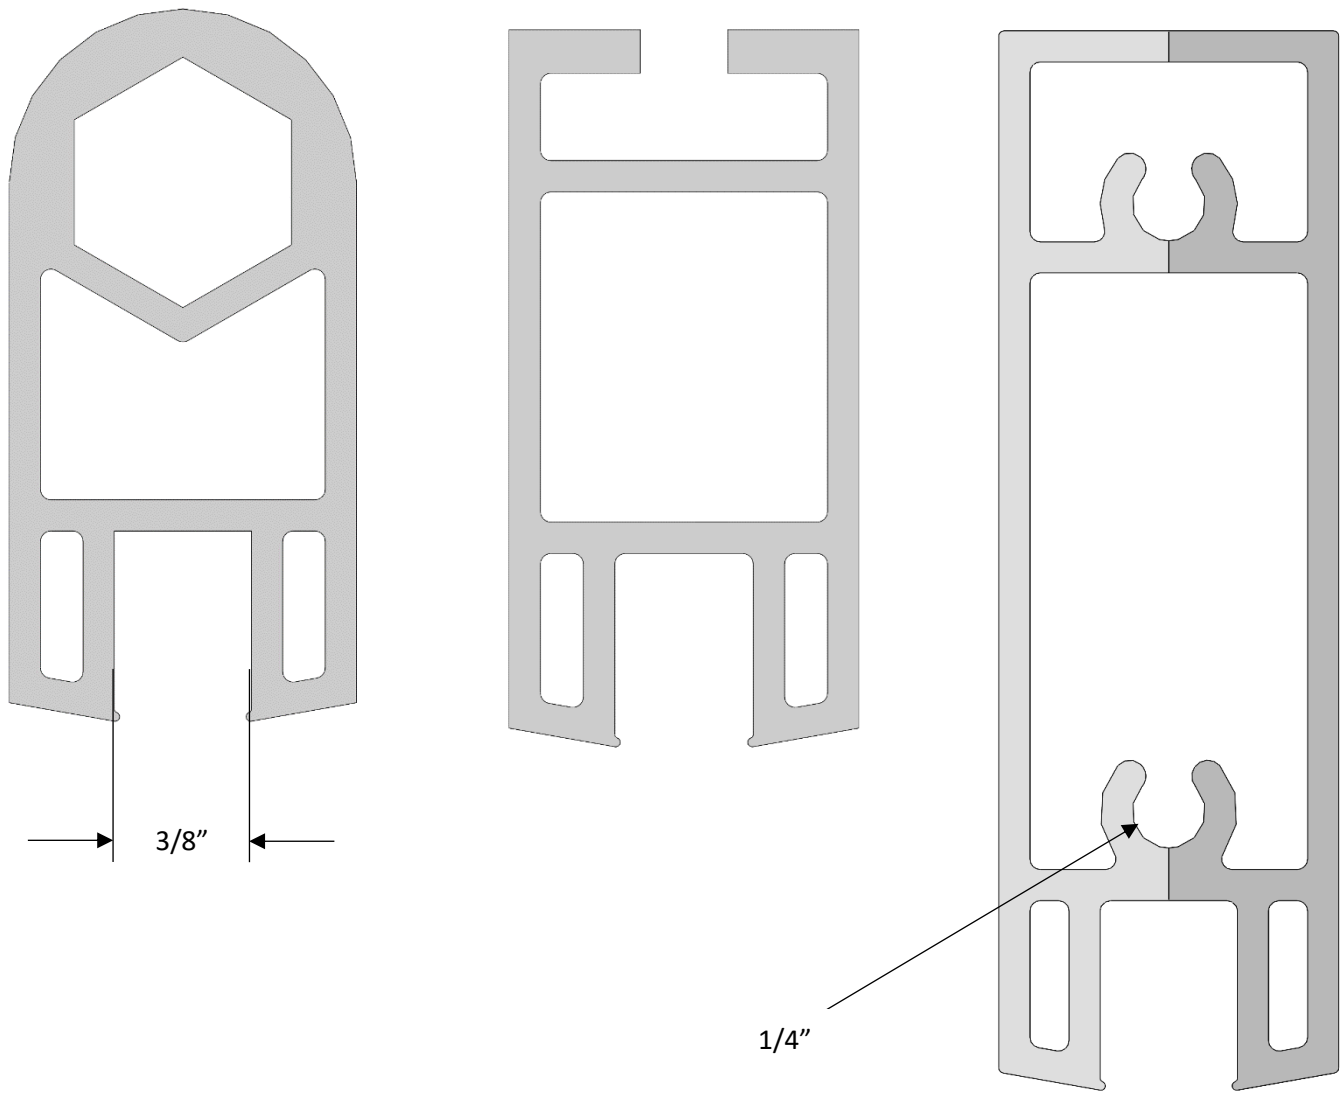
3/16" Screw Boss 2005 – Dec 2015 (Uses Screw P/N P100262)

1/4" Screw Boss Jan 2016 – June 2021 (Uses Screw P/N 2913)

Used From June 2021 – Current
